Car Stereo
Service Bulletin

CSA-14

No. 334

Subject: Skipping When Outer Tracks Are Played.

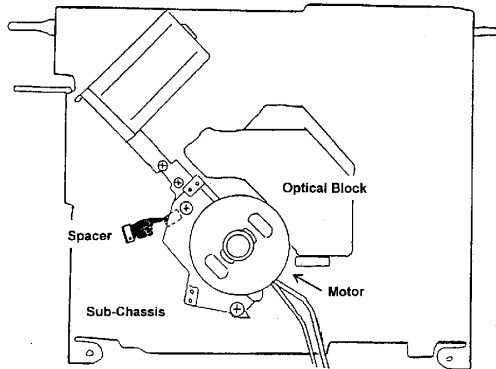
Symptom:
(57)

The customer may complain that skipping occurs when outer tracks of discs are played. This may occur if the mechanism sub-chassis is bent, which makes it more difficult to maintain proper focus at the outer portions of discs.

Solution: If the customer complains of this problem, add a spacer to the sub-chassis as shown below.

REF	DESCRIPTION	PART NUMBER
-	SPACER	2-626-870-21
